Waste Permits Division Correspondence Cover Sheet

Facility Name: Beck Landfill

Permit or Registration No.: 1848A

MUNICIPAL SOLID WASTE PERMIT MAJOR AMENDMENT-3RD NOD RESPONSE

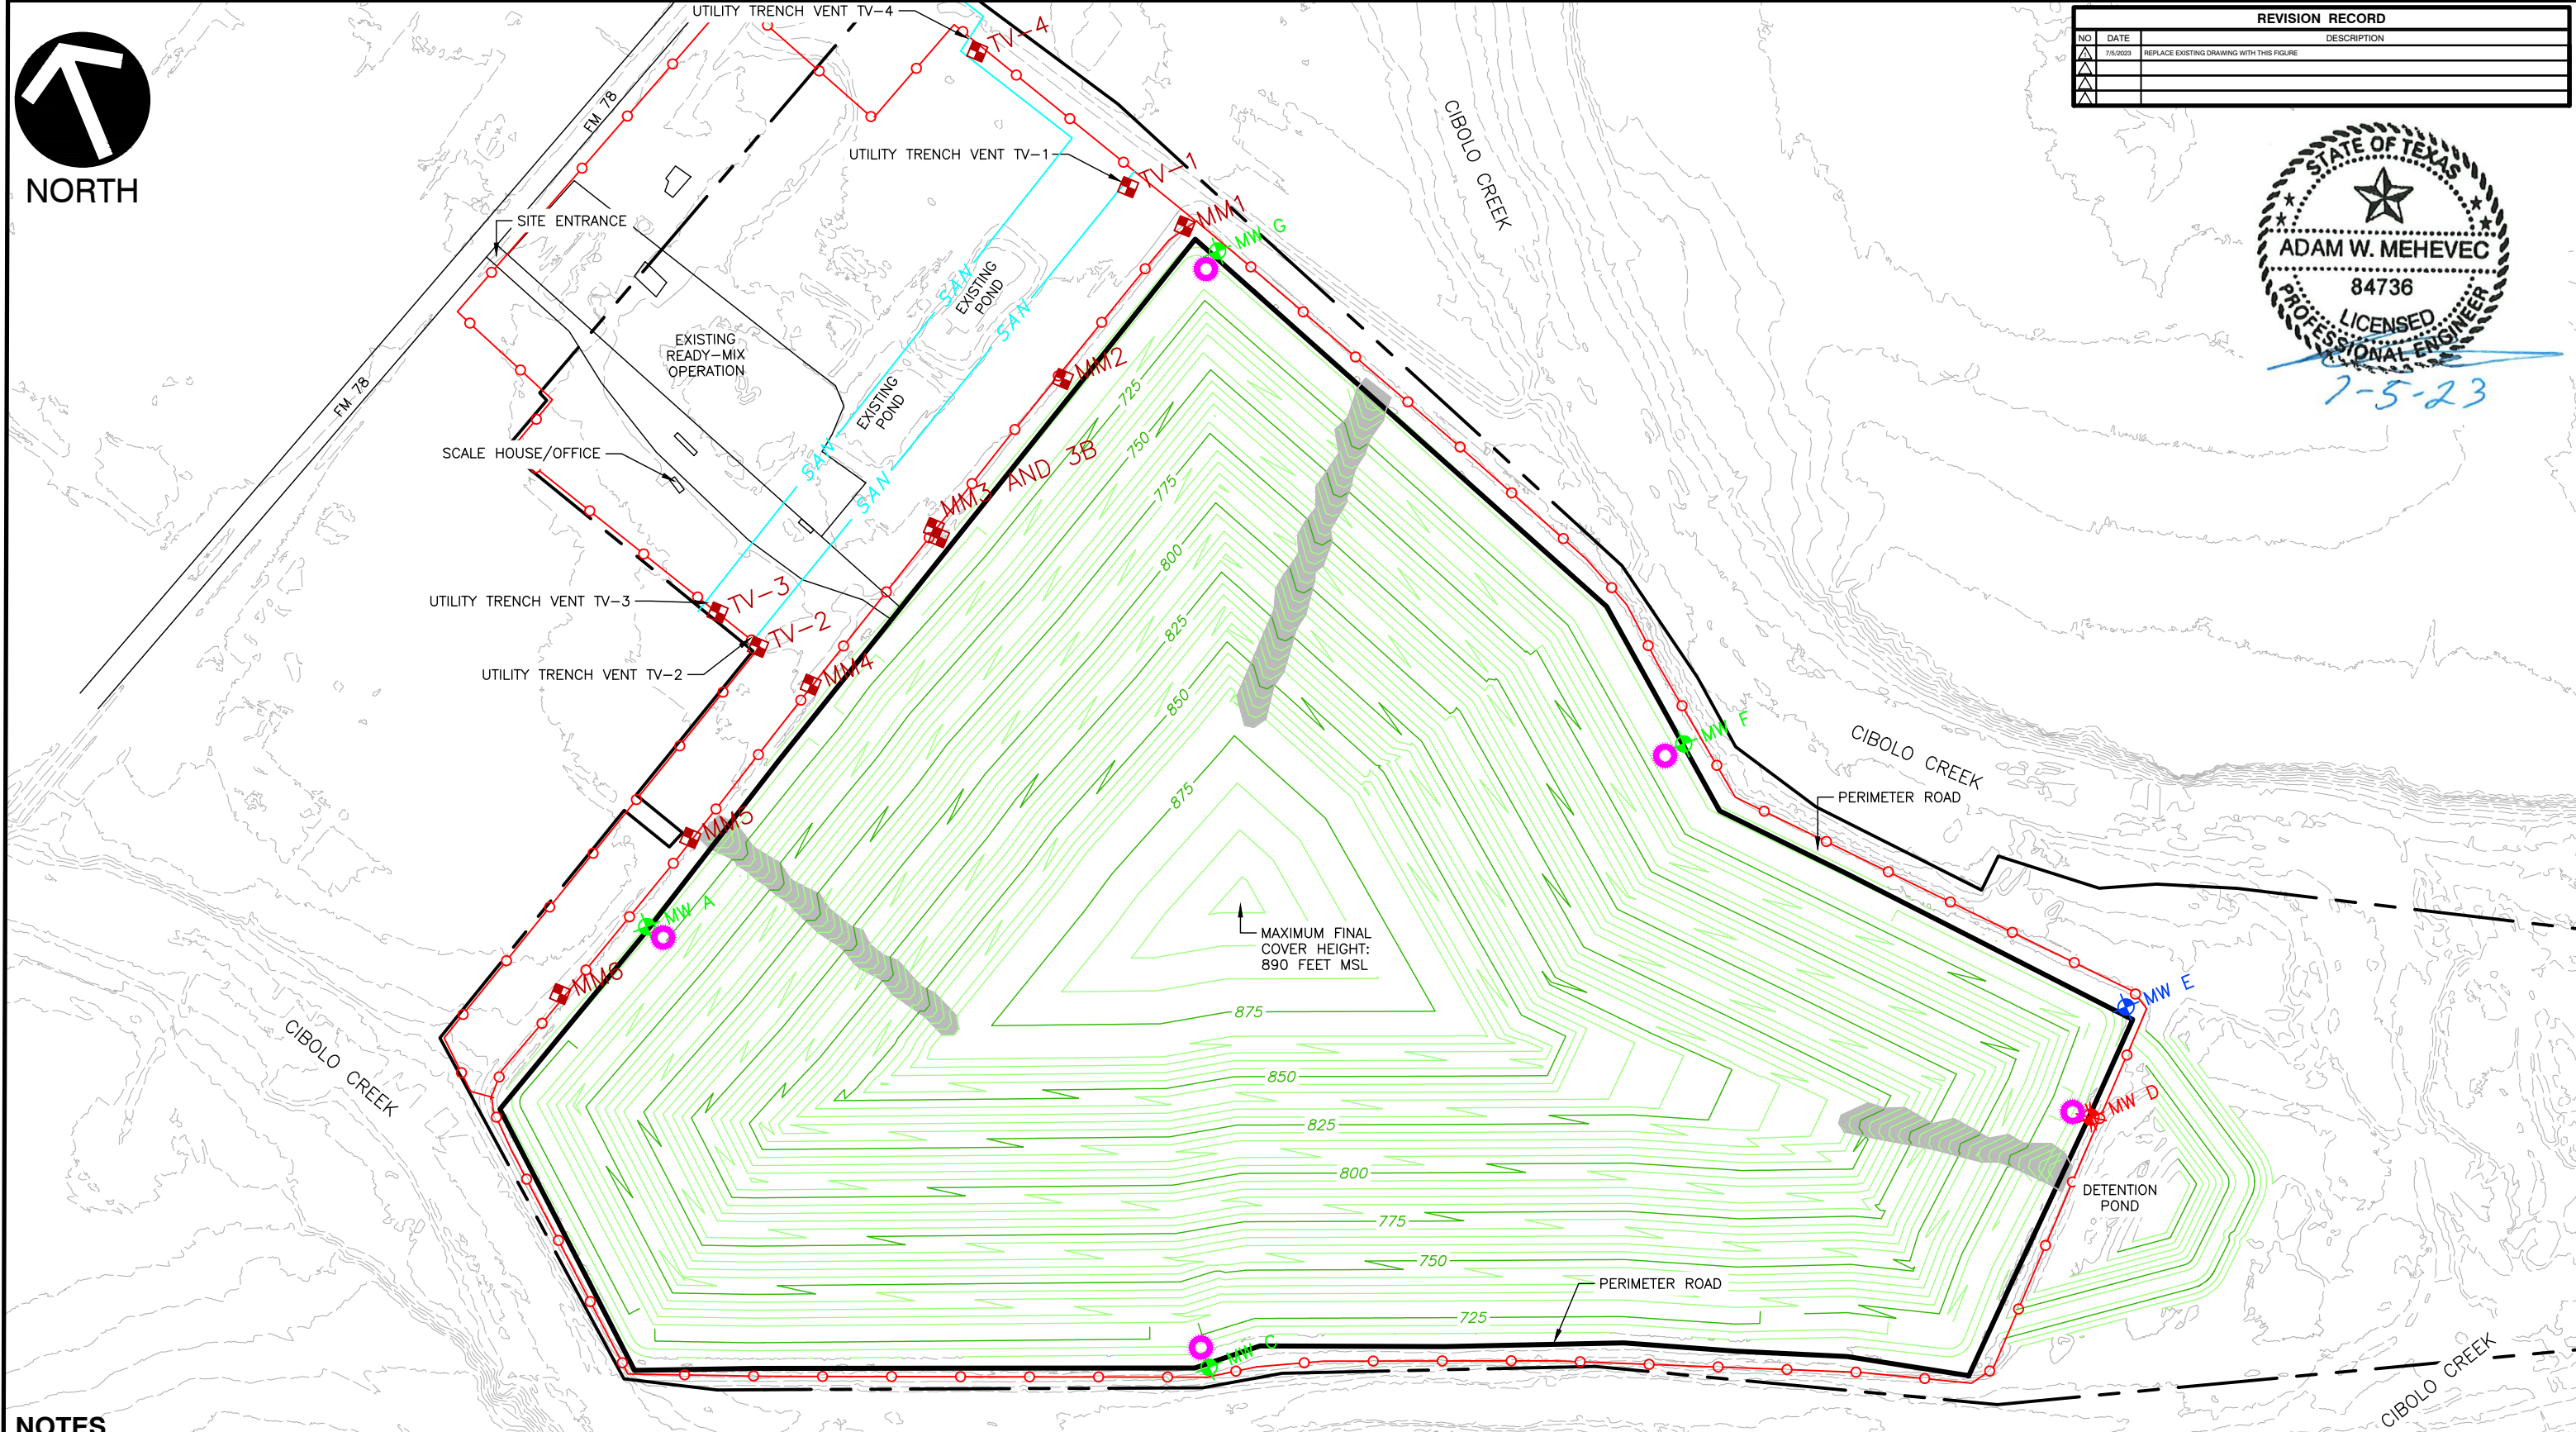
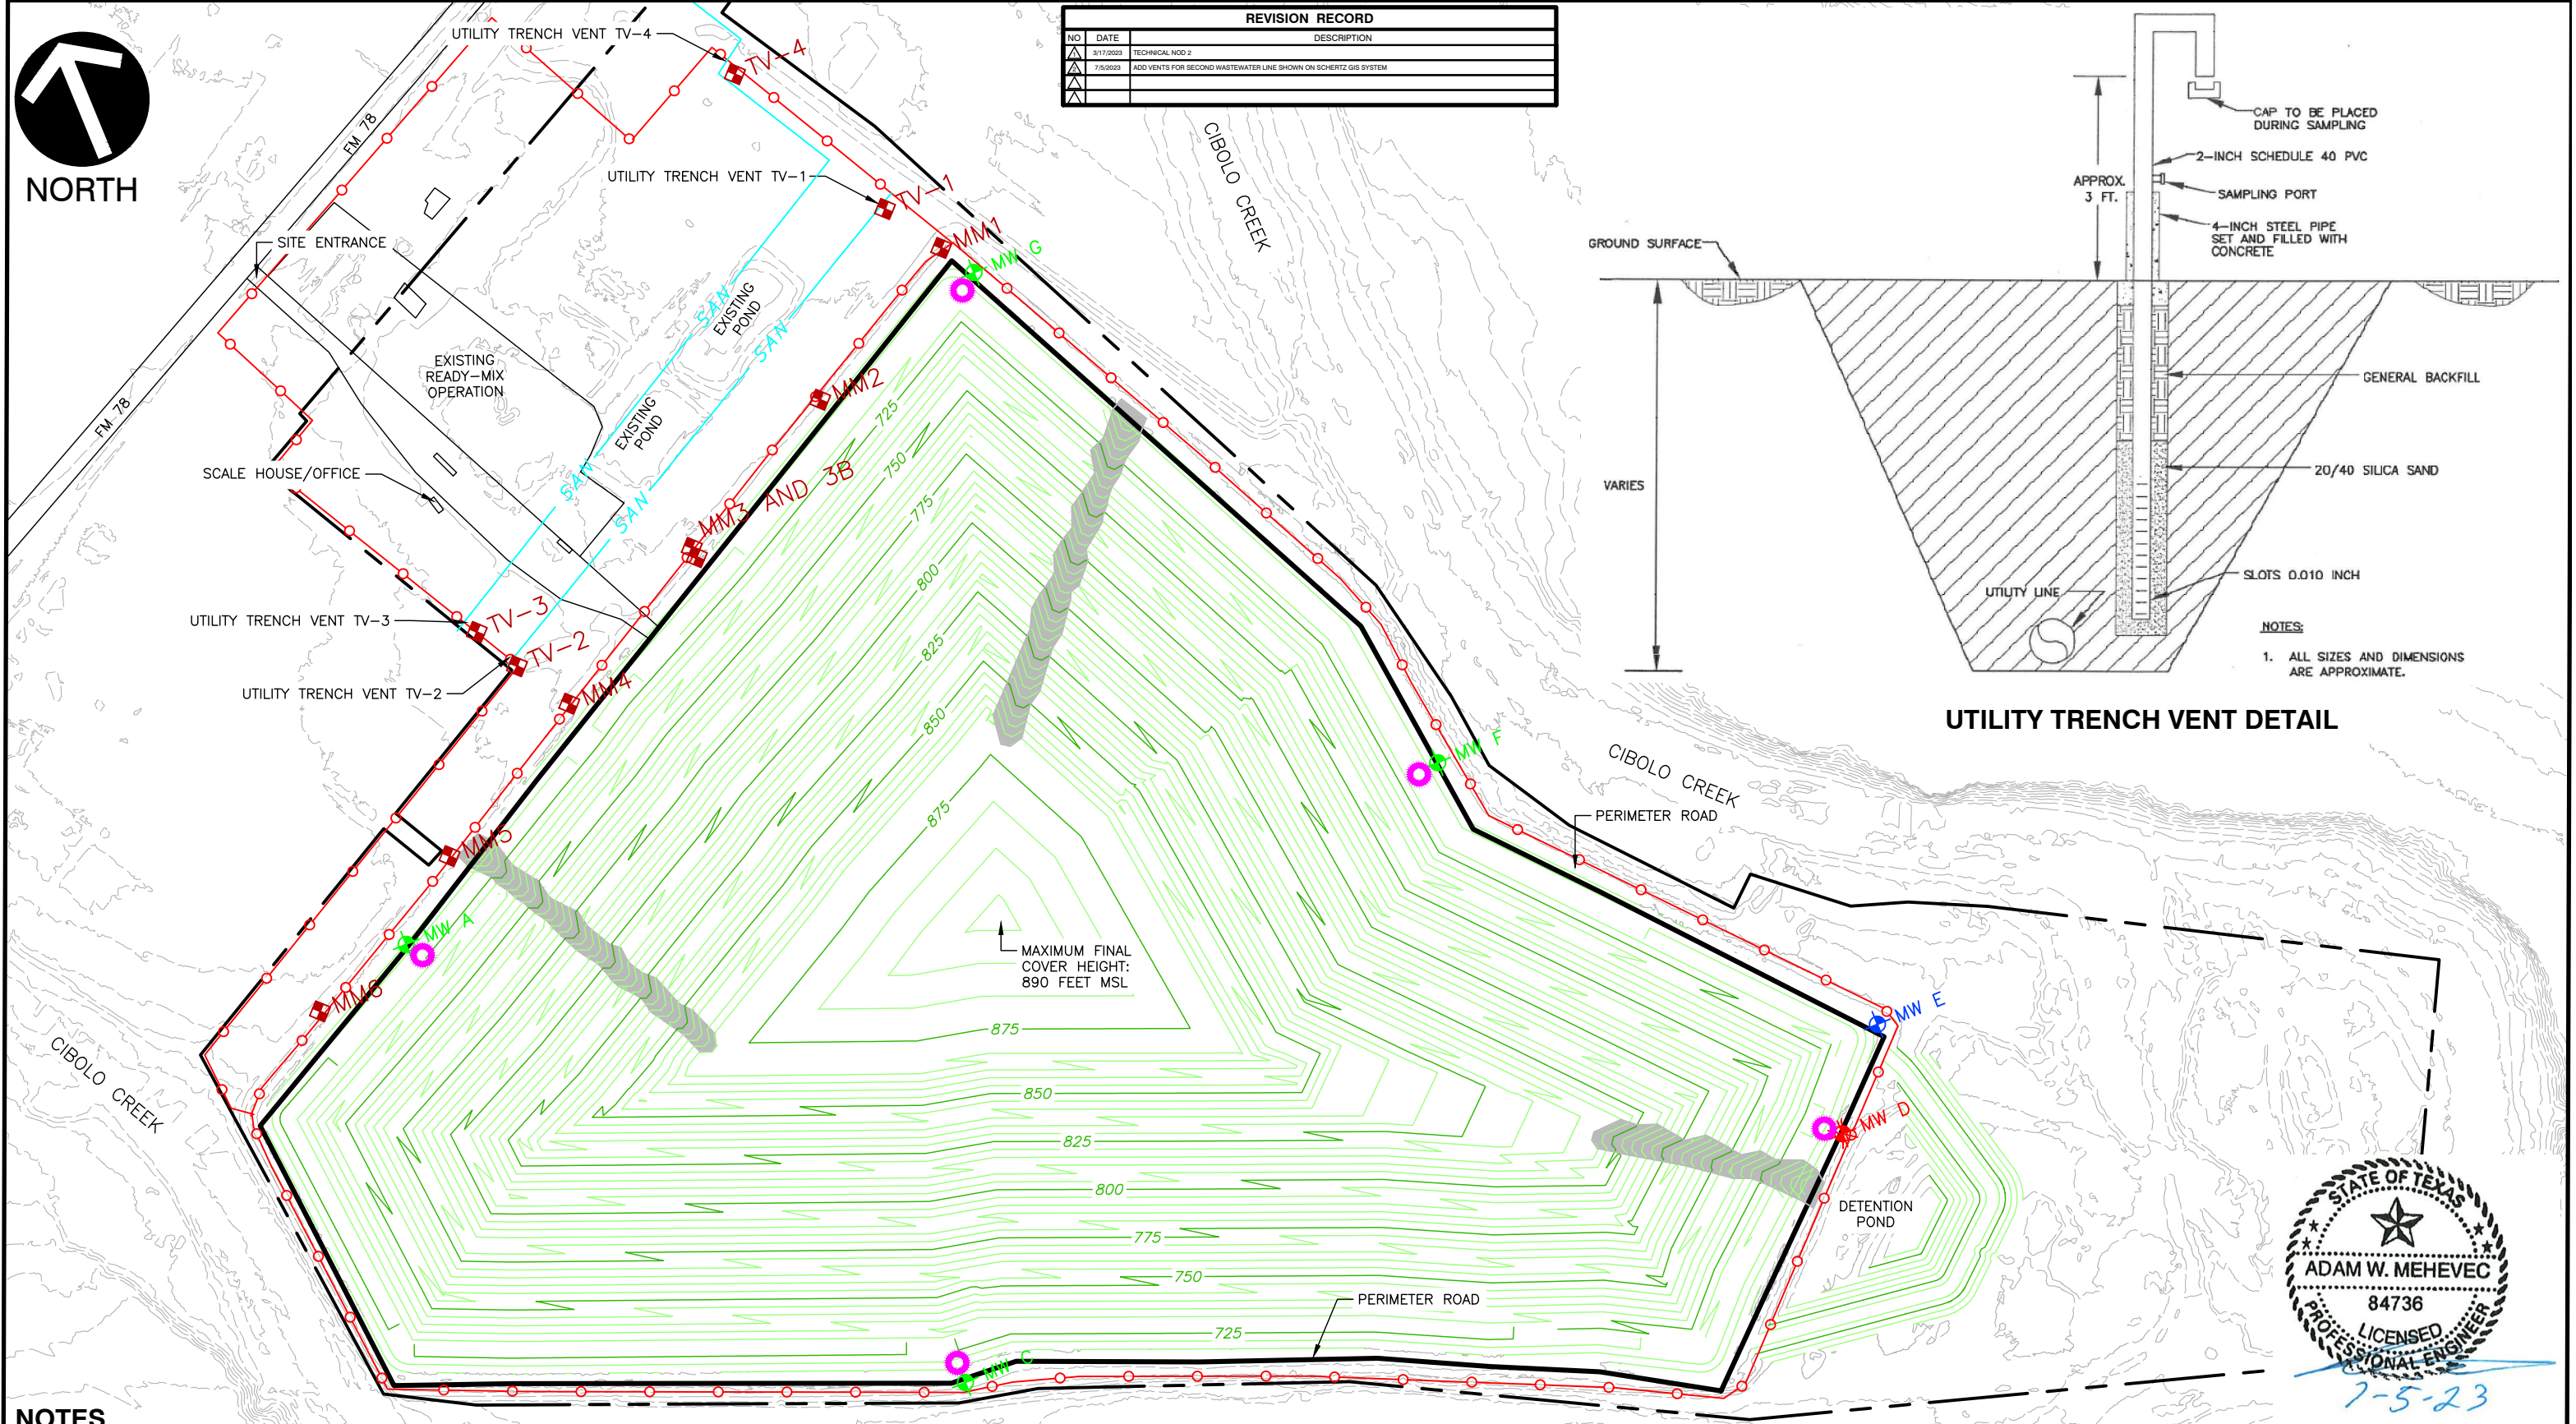
| NOD ID | MRI ID | App. Part | Citation | Location | NOD Description | Response |
|--------|--------|-----------|------------|----------------------|---|---|
| 38 | 656 | Part III | 330.371(f) | Attachment G | Revise Figure G-3 to show all of the underground utility easements indicated earlier on Figure 2-6 in Part II. | Additional vents have been shown on Figure G-3 for the 2nd wastewater line. |

| REVISION RECORD | | |
|-----------------|-----------|--|
| 2 | 7/5/2023 | ADD VENTS FOR SECOND WASTEWATER LINE SHOWN ON SCHERTZ GIS SYSTEM |
